Access Compliance Report

Public Rights-of-Way

Intersection ID: 10077	Main Street: E_35TH_ST	Cross Street: N_DAVIDSON_ST	Location: N
ADA ID: ECD112C1C926	Ramp Type: PerpDiag	Initial Pass/Fail: Fail	Overall Compliance: No
			Severity Score: 13.75

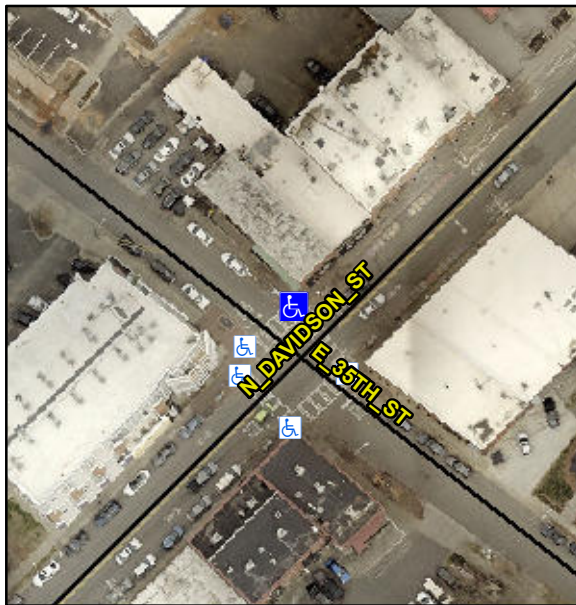
R304.2.2, R304.5.3

Compliance	Description	Data	Compliance	Description	Data
N/A	Ramp Length (in)	76.0	No	Ramp Slope (%)	9.7
Yes	Ramp Width (in)	48.0	No	Ramp XSlope (%)	2.1
N/A	Flare Type LT	N/A	N/A	Flare Type RT	N/A
N/A	Flare Slope LT (%)	N/A	N/A	Flare Slope RT (%)	N/A
N/A	Flare Traversable LT?	N/A	N/A	Flare Traversable RT?	N/A
N/A	Landing Length (in)	N/A	N/A	DWS Provided?	N/A
N/A	Landing Width (in)	N/A	N/A	DWS Contrast?	N/A
N/A	Landing Slope (%)	N/A	N/A	DWS Length (in)	N/A
N/A	Landing X Slope (%)	N/A	N/A	DWS Full Width?	N/A
N/A	Landing Curb? (Y/N)	N/A	N/A	DWS Offset (in)	N/A
N/A	Shared Landing?	N/A			
N/A	Gutter Ponding?	N/A	N/A	Gutter Slope (%)	N/A
N/A	Gutter Lip Ht (in)	1.0	N/A	Gutter X Slope (%)	N/A
N/A	Painted X Walk1?	Yes	N/A	Painted X Walk2?	Yes
	X Walk 1 Direction	To SW		X Walk 2 Direction	To SE
N/A	X Walk 1 Width (in)	110.0	N/A	X Walk 2 Width (in)	89.0
	X Walk 1 Slope (%)	1.2		X Walk 2 Slope (%)	3.7
	X Walk 1 X Slope (%)	3.8		X Walk 2 X Slope (%)	1.5

Remove & Replace Curb Ramp With Two New Directional Ramps or Equivalent.
